## **Item 3 - Correspondence**

Testimony for Creekside at Cabin Branch, Preliminary Plan No. 120200050T

Testimony for Creekside at Cabin Branch, Preliminary Plan No. 120200050

**Written Testimony – Pulte’s Development, Creekside at Cabin Branch**  
**Preliminary Plan No. 120200050**

Figure 1

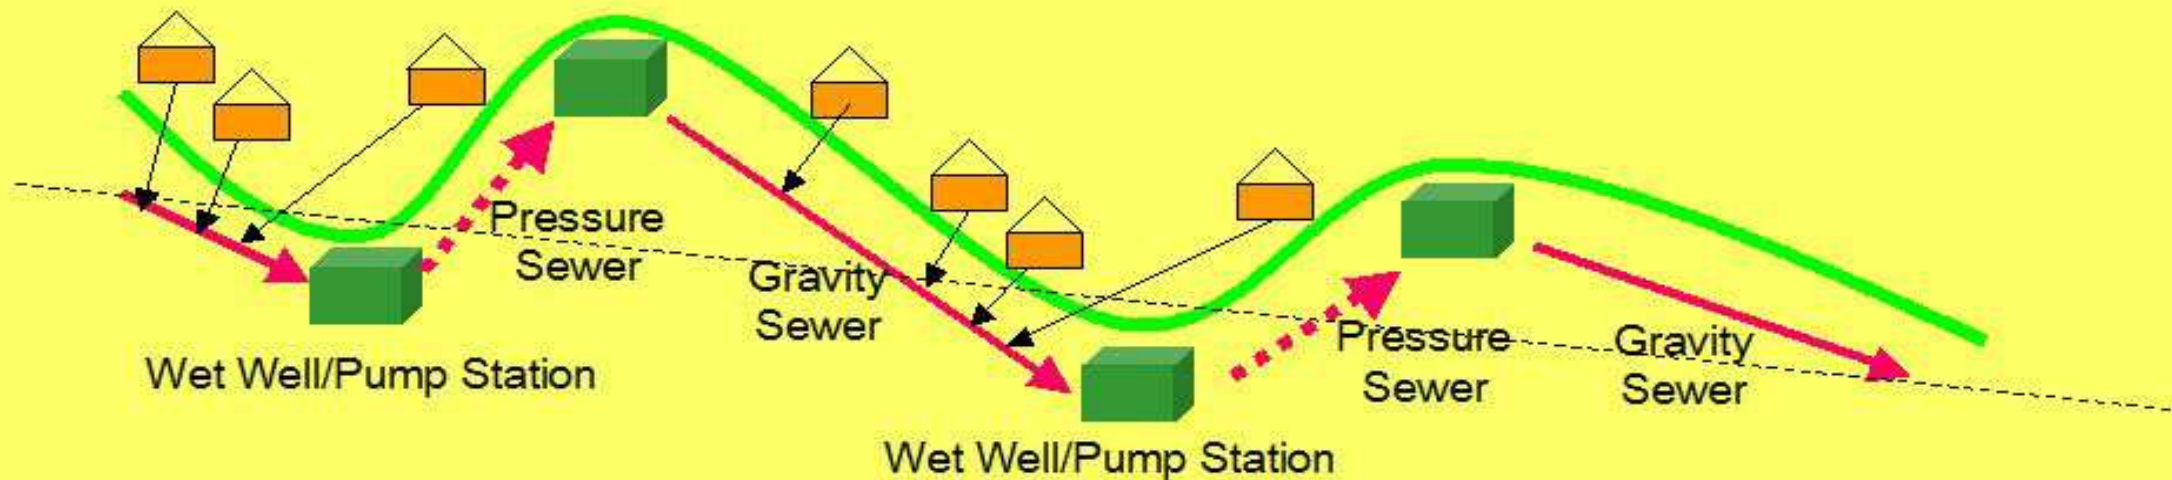
In a SERIAL model, the failure of any one pump results in a system failure  
(and the pump is generally at the bottom of a valley)

Spill is proportional to number of houses "upstream."

Figure 2

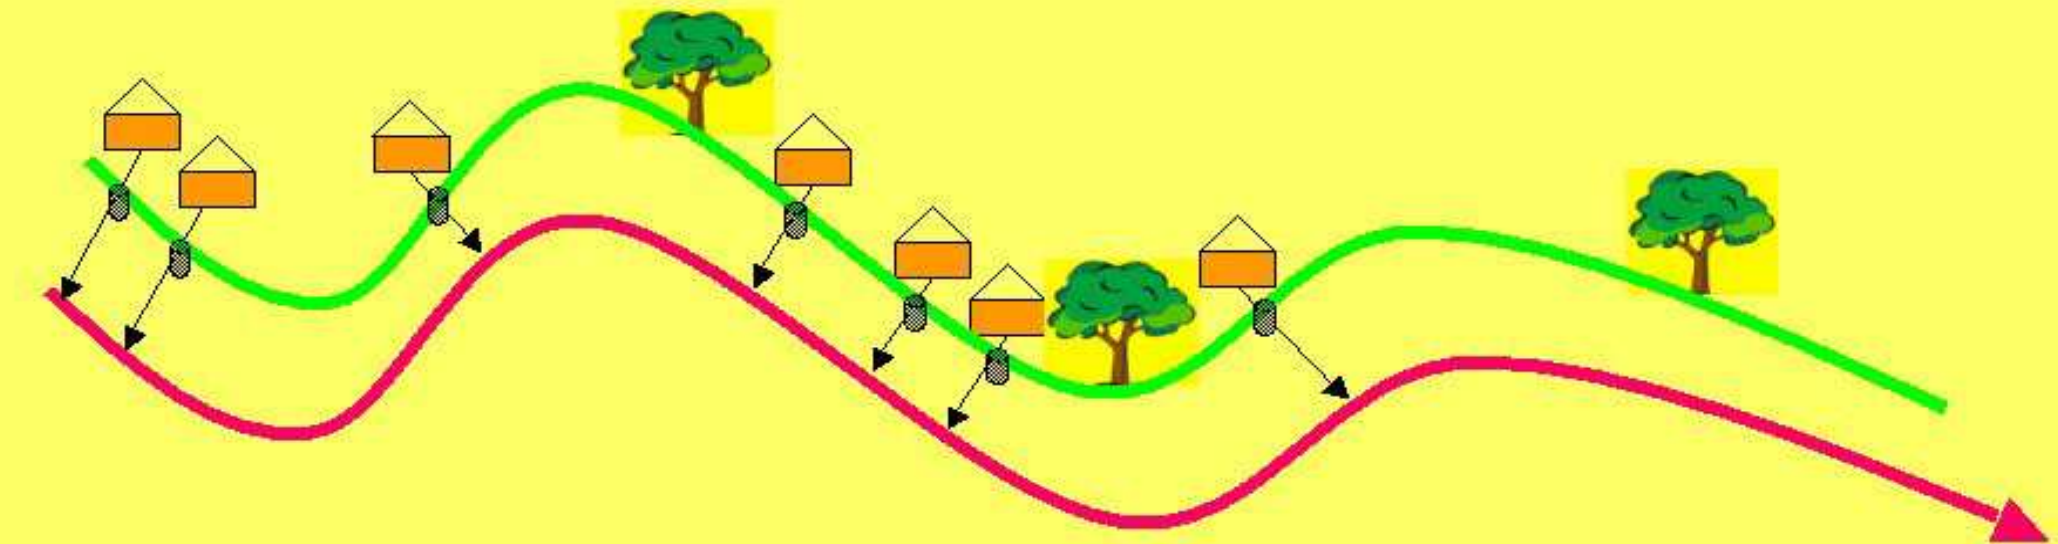
In a PARALLEL model, the failure of any one pump does not result in a system failure,  
just loss of capability at that one site.

It is recommended that the developer consider the use of pressure grinder pumps as the primary way to transport wastewater from homes to the main interceptor. Further, the system should be planned such that if power is disrupted or a component fails, the waters of Ten Mile Creek and those of Little Seneca Reservoir should not be compromised.

**Figure 3-12**  
**Alternative 12 - Gravity + 3 Pump Stations and**  
**Grinder Pump Systems (No Observation Drive)**

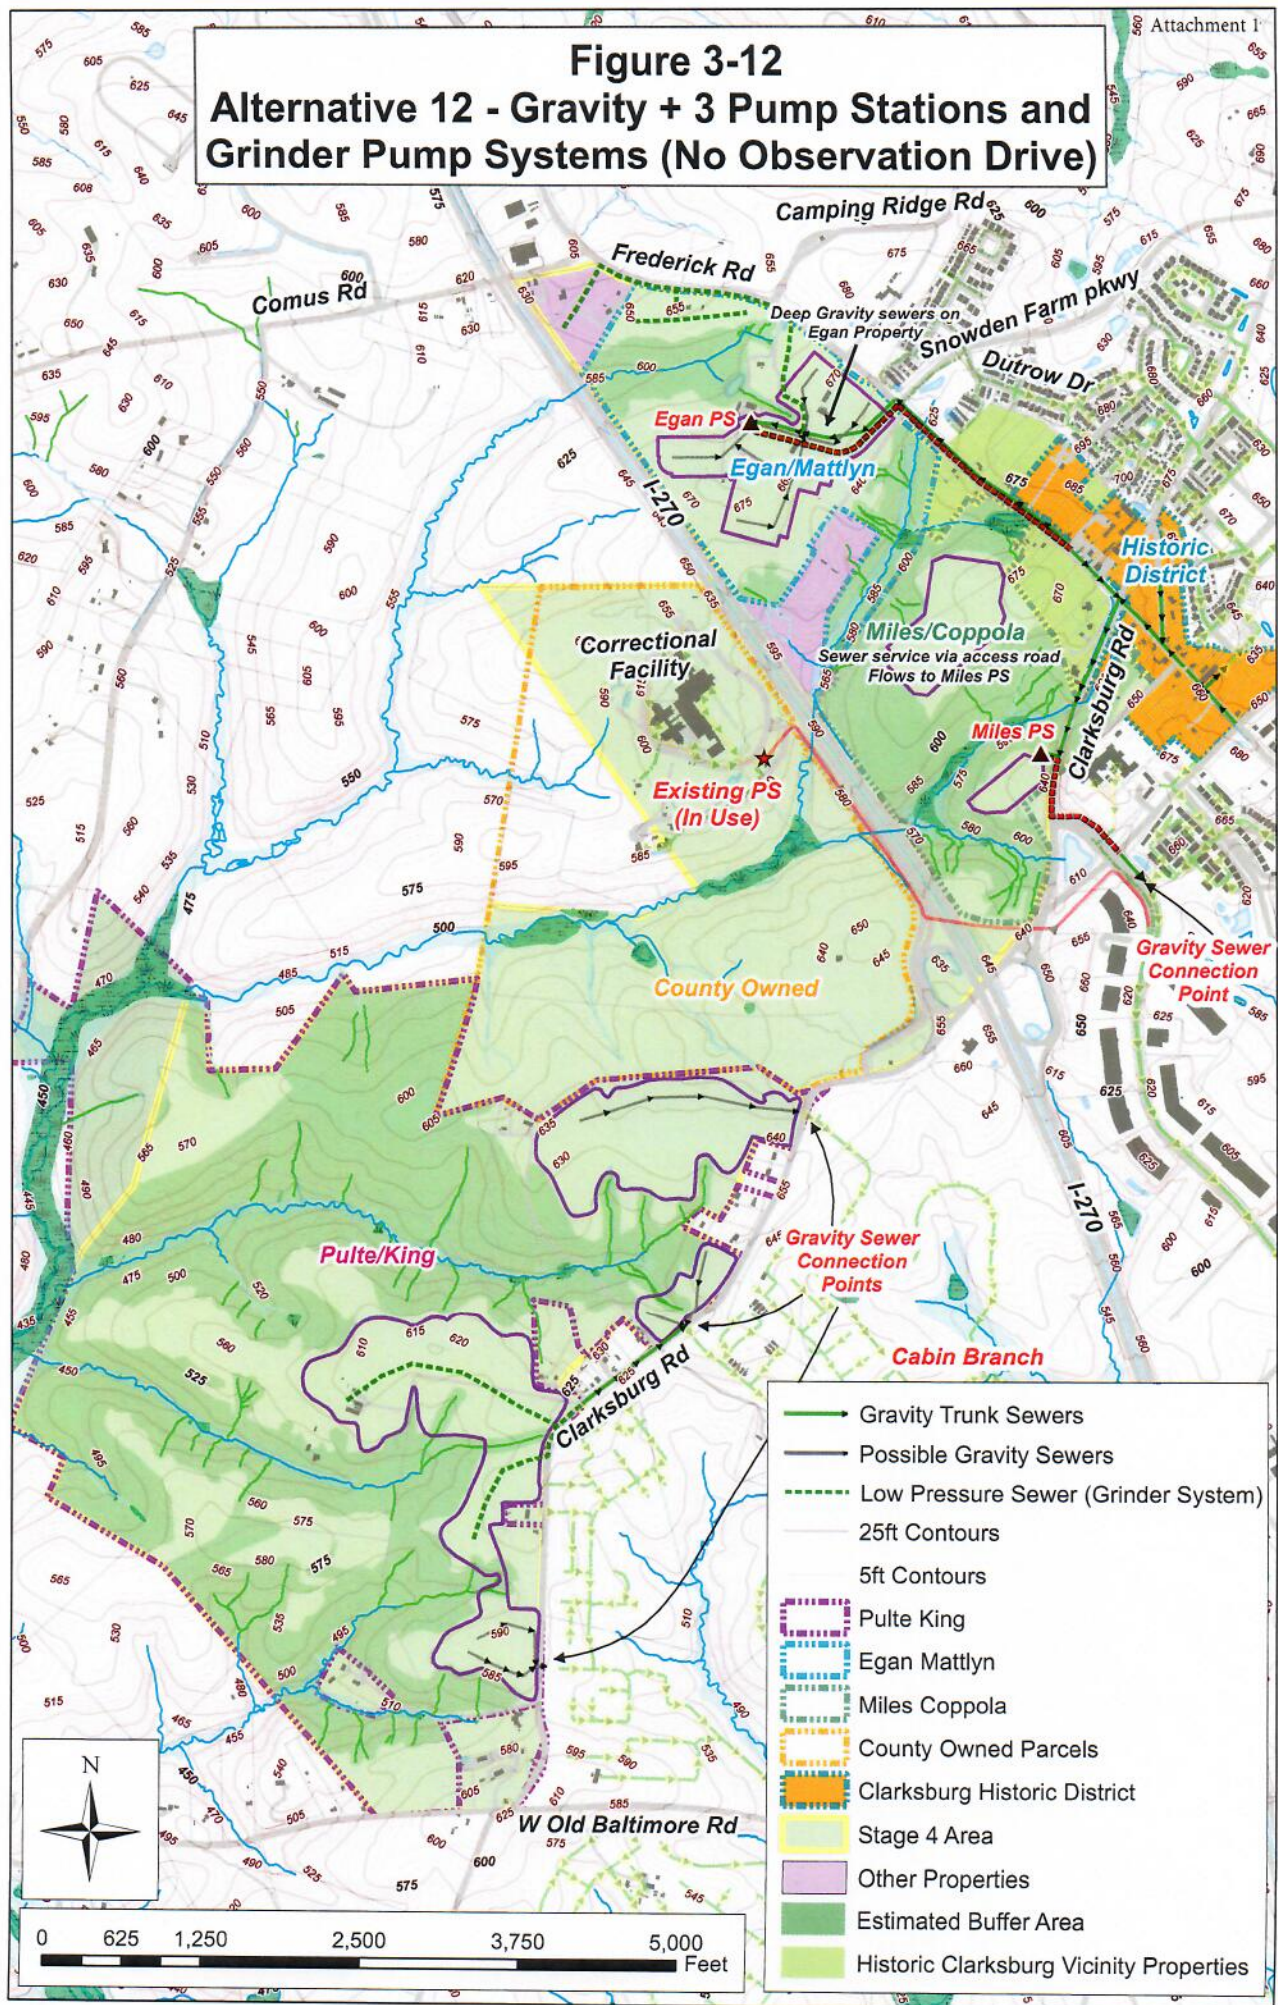
I was surprised to read in the staff report that Pulte's "residential development has been designed using individual grinder pumps and the proposed force main sewer system". Installing a force main on Pulte's property, along with an implied pump station to power it, does not conform to WSSC's preferred sewer plan, "Alternative 12", which the Planning Board endorsed and the Montgomery County Council adopted in Resolution 18-551. No force mains or pump stations are slated for this part of the Ten Mile Creek watershed. Some of WSSC's earlier alternatives did have a pump station and force main on Pulte's property, but these were dropped in favor of a low pressure sewer system with grinder pumps.<sup>1</sup> This newer technology was chosen to eliminate a stream crossing and reduce environmental impacts, such as the potential for sewage spills into the two very sensitive tributaries. Grinder pumps have been used successfully to sewer developments in other environmentally-sensitive areas of the County.<sup>2</sup>

This raises many questions that must be resolved before the application can be approved: what exactly is Pulte's sewer plan? Do they plan to use grinder pumps throughout the project, as called for in Alternative 12, or only in a few places? Where would the force main be and the pump station needed to power it? What changes must be made both to the sewer and the development plans to come into compliance with what the Council approved in Resolution 18-551? The staff report failed to address these questions.<sup>3</sup>
